SYDNEY MODERN CONCERNS: BRIEFING PAPER

10 October 2017

Letter from Andrew Andersons AO to Sydney Modern Project team, May 2017

Re SYDNEY MODERN

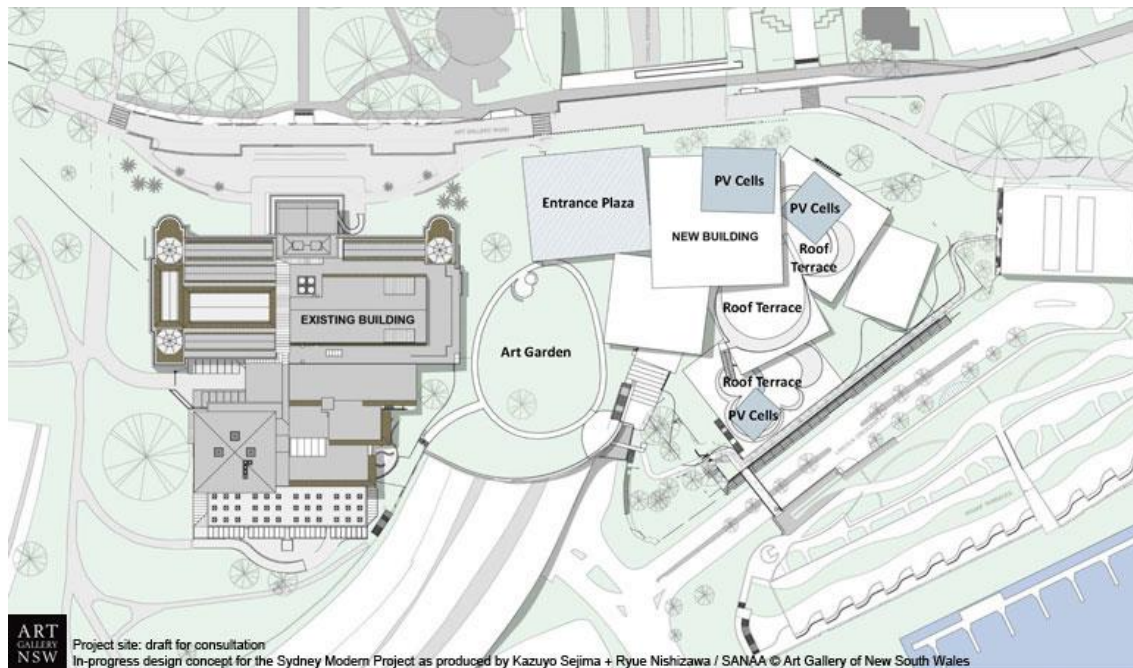
The Gallery has released a sketch drawing of the new design on this new location from a north east perspective.

The proposed building appears to occupy a footprint equal to or exceeding that of the existing Gallery buildings <https://www.artgallery.nsw.gov.au/sydney-modern-project/about/design-concept/> In its new location, high on the grassy slope when viewed from Woolloomooloo, its size will be obvious and obtrusive. Until the Gallery recently updated its website, inquiries by the Friends have met with a response that details are not yet available as to the precise location, or dimensions and elevations of the building.

A newspaper report described the eight pavilions as low-lying, but there is a significant drop from the land bridge level to the Fuel Tank Area, and without elevations or depictions of the building it is impossible to visualise the effect when viewed from the Domain or from below.

The tabled perspective looking north east, still shows an unfortunate juxtaposition or collision of unrelated architectural language that can best be resolved by increasing the distance between the buildings, leaving the landbridge over the expressway clear of structures other than the entrance canopy.

The computer-generated image with its questionable perspective and rendering of light does little to advocate the design.
